Model: Finisher_SR4090_SR4100	Date: 7-Oct-13	No.: RD703002
-------------------------------	----------------	---------------

Subject: SR4100: Troubleshooting Creases and Jam in stapler unit		Prepared by: Hiroaki H Matsui	
From: 1st PP Tech Service Sec., PP Tech Service Dept.			
Classification:	<input checked="" type="checkbox"/> Troubleshooting	<input type="checkbox"/> Part information	<input type="checkbox"/> Action required
	<input type="checkbox"/> Mechanical	<input type="checkbox"/> Electrical	<input type="checkbox"/> Service manual revision
	<input type="checkbox"/> Paper path	<input type="checkbox"/> Transmit/receive	<input type="checkbox"/> Retrofit information
	<input type="checkbox"/> Product Safety	<input type="checkbox"/> Other ()	<input type="checkbox"/> Tier 2

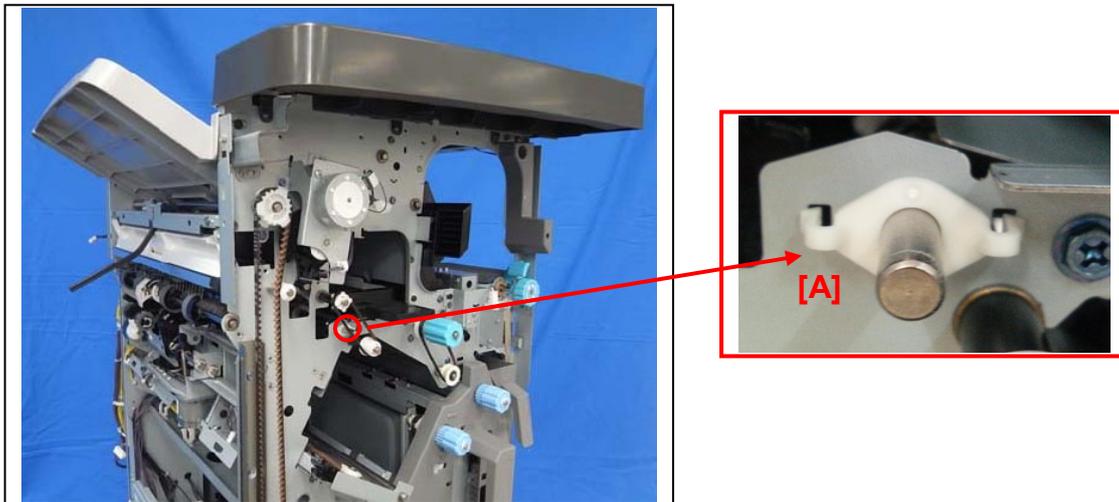
Bushing [A] is not set correctly and slipped from the machine during our factory assembly procedure. As a result, the shift motor shaft cannot rotate correctly.

The affected bushing is attached in the final assembly procedure. In addition, to ensure that the position of the bushings is correct, a visual inspection has been added to the production procedure in the factory. Please refer to the cut-in serial numbers below.

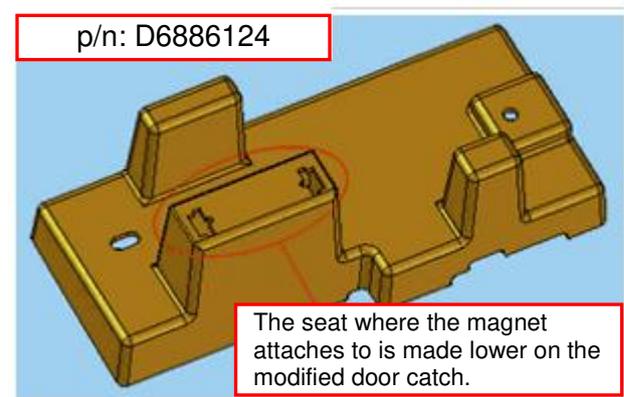
The magnet attached to the magnetic door catch is loose and the front cover does not completely close, displaying a front cover open error message on the operation panel.

The magnet was set incorrectly at the factory.

- 1) If the magnet is loose, reattach it.
If the magnet cannot be reattached properly, procure the modified magnetic door catch (p/n: D6886124).
- 2) A check procedure to confirm proper attachment of the magnet was added at the factory.

- 3) The magnetic door catch was modified to enable attachment of the magnet with better precision.

<Old>

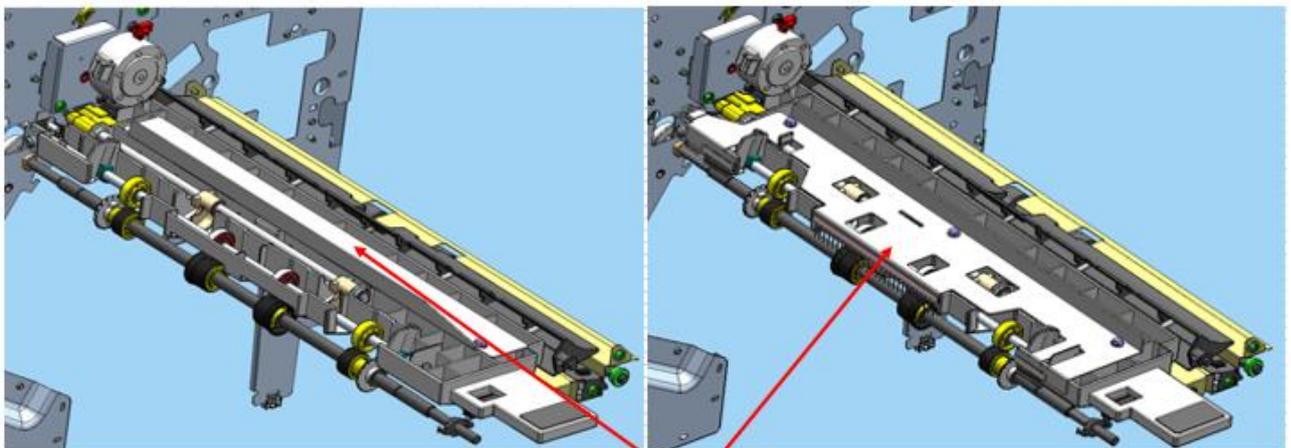
Change 1 : Shape of the supporting plate in the straight-path

Change 2 : Addition of discharge brushes in the straight-path

D6882268 → D6882267
SUPPORTING PLATE:GUIDE PLATE:SHIFT:OPEN AND CLOSE:ASS'Y

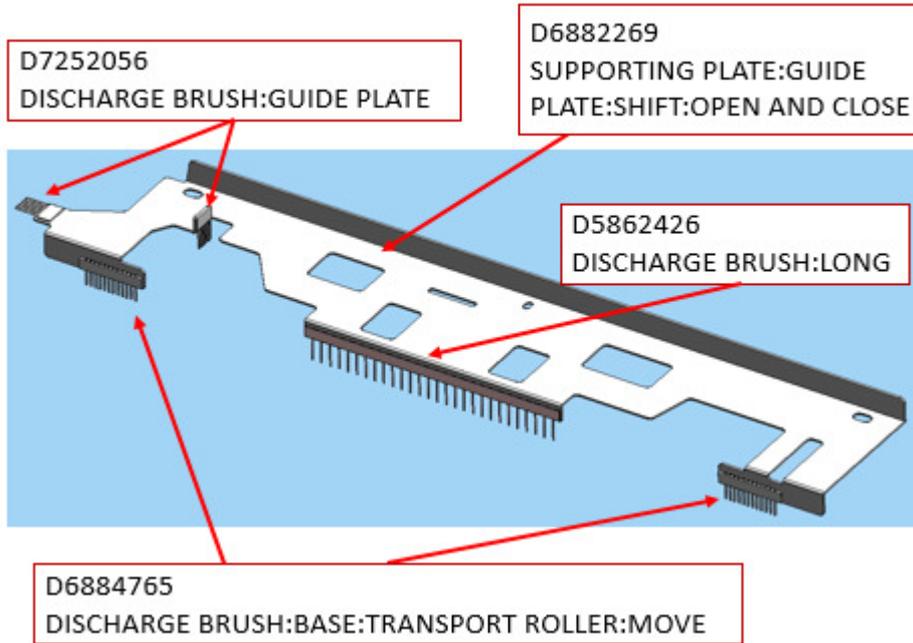
Discharge brush (p/n: D7252056) was attached to the gate pawl (p/n: D6882510).

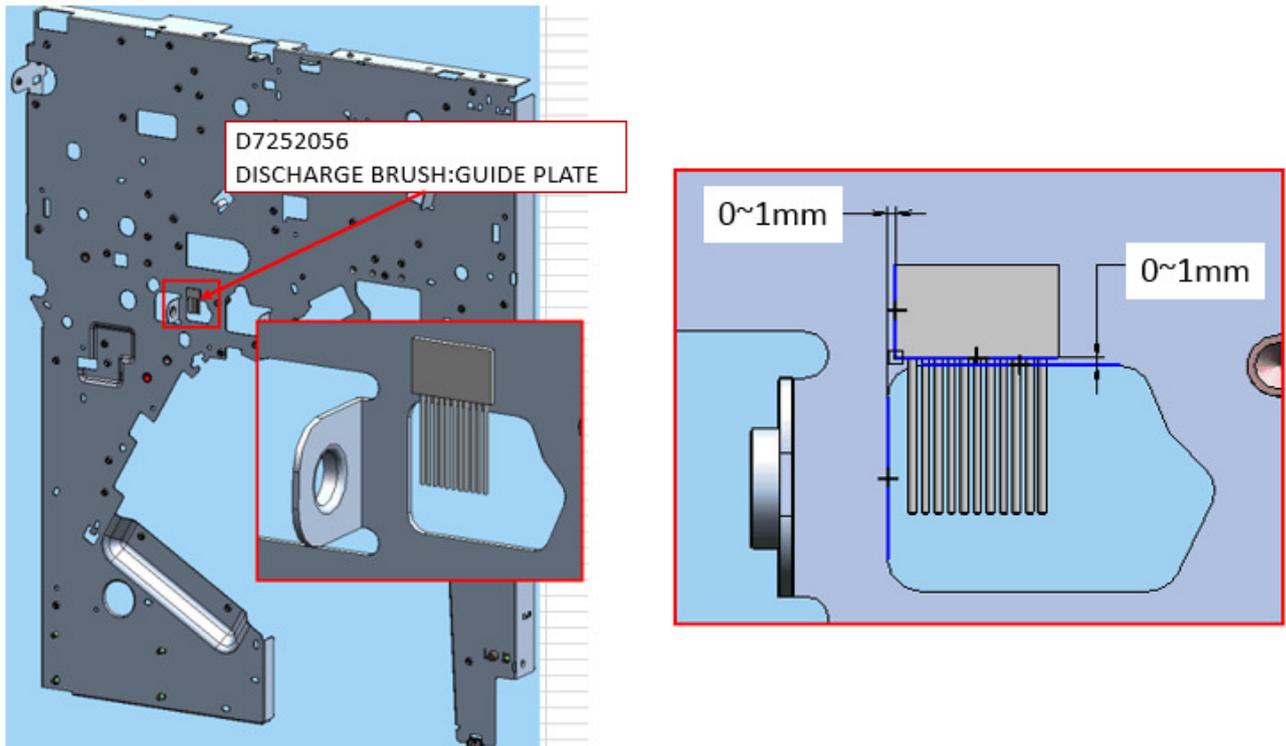
Discharge brush (p/n: D7252056) was attached to the rear plate.

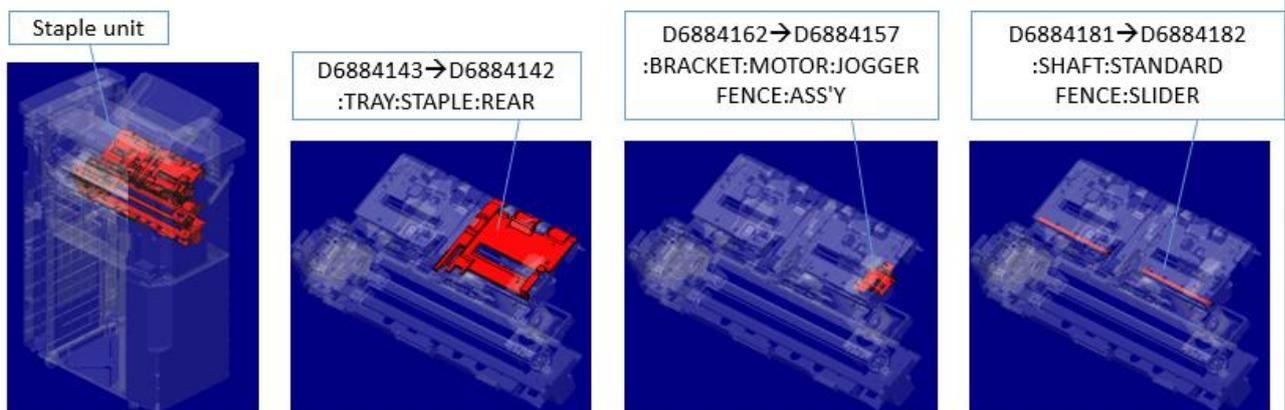
Change : Design modification of the stapler unit components

NOTE: The above parts must be replaced as a set.

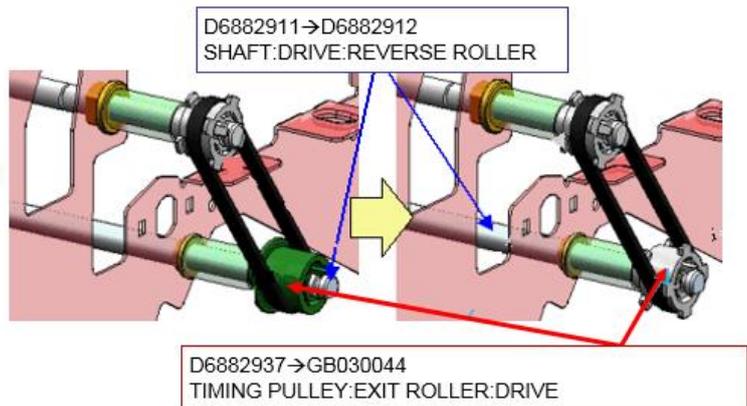
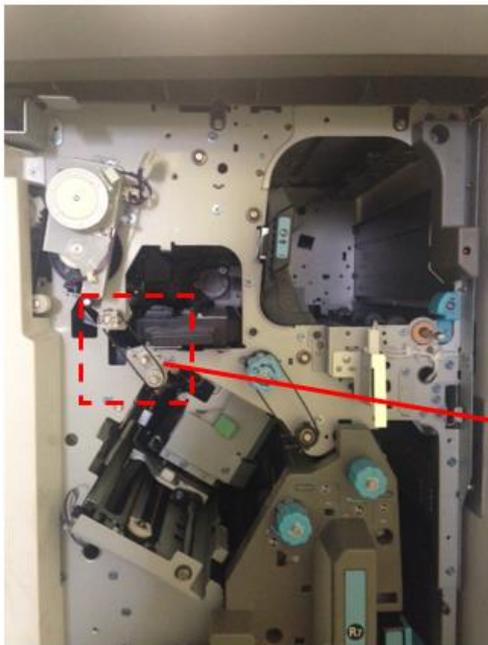
Change : Modification of the pulley on the paper exit drive shaft

NOTE: The above parts must be replaced as a set.

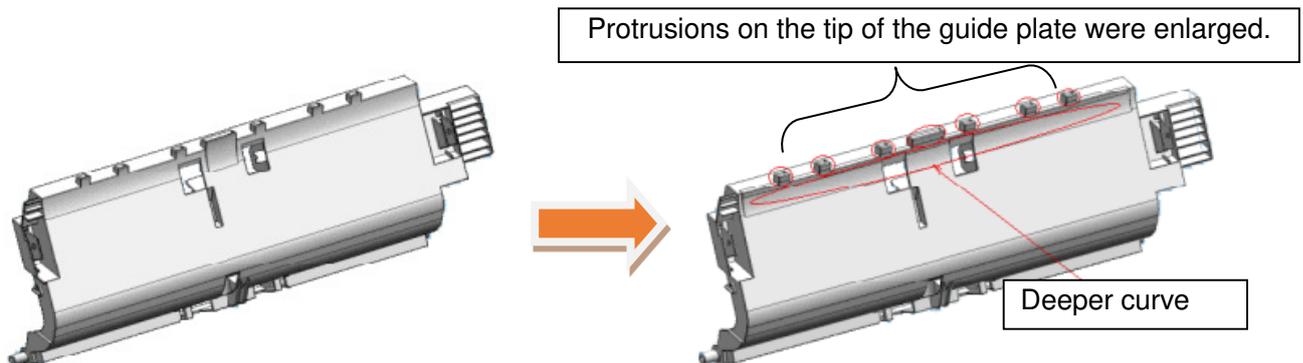
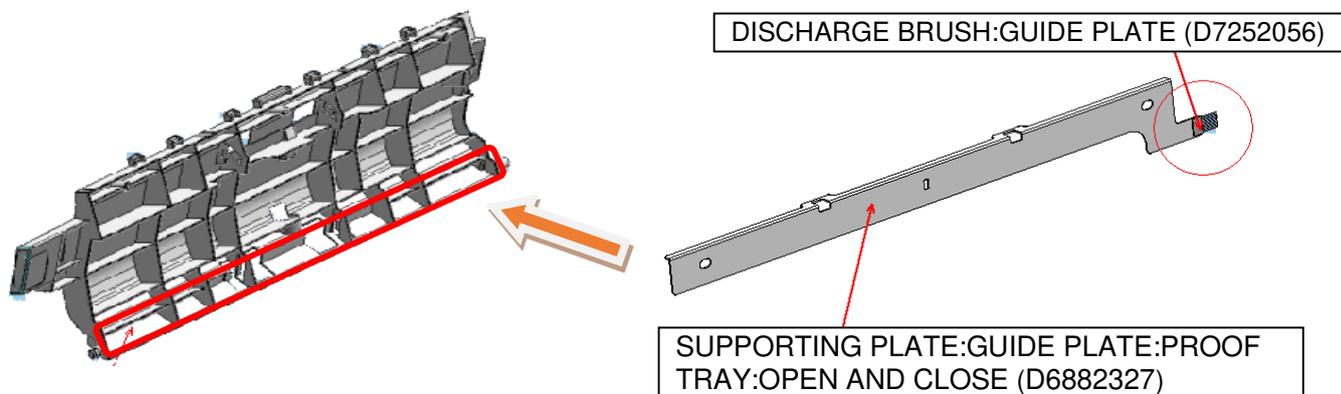
Change Reason : Guide plate of the proof tray
: For higher reliability

A supporting plate attached with a discharge brush (p/n: D7252056) was added to the modified guide plate.

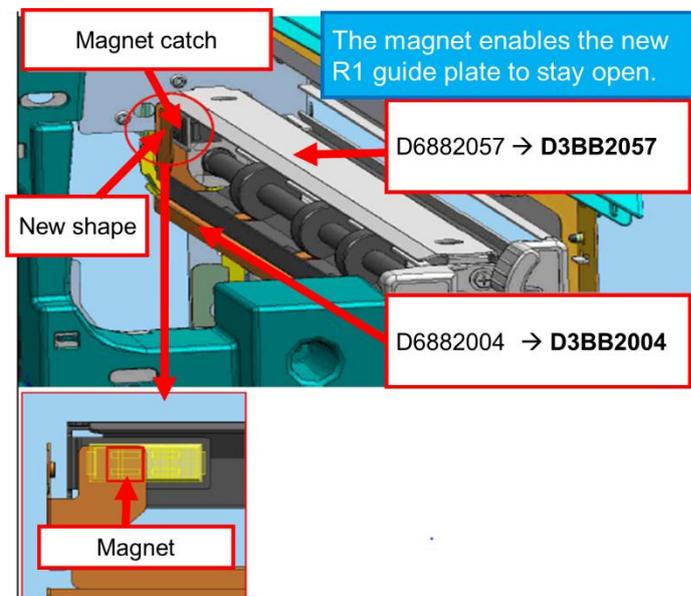
Change : A magnet was added to the R1 guide plate

The R1 guide plate consists of the upper plate with the magnet attached and the lower plate with the magnet catch.
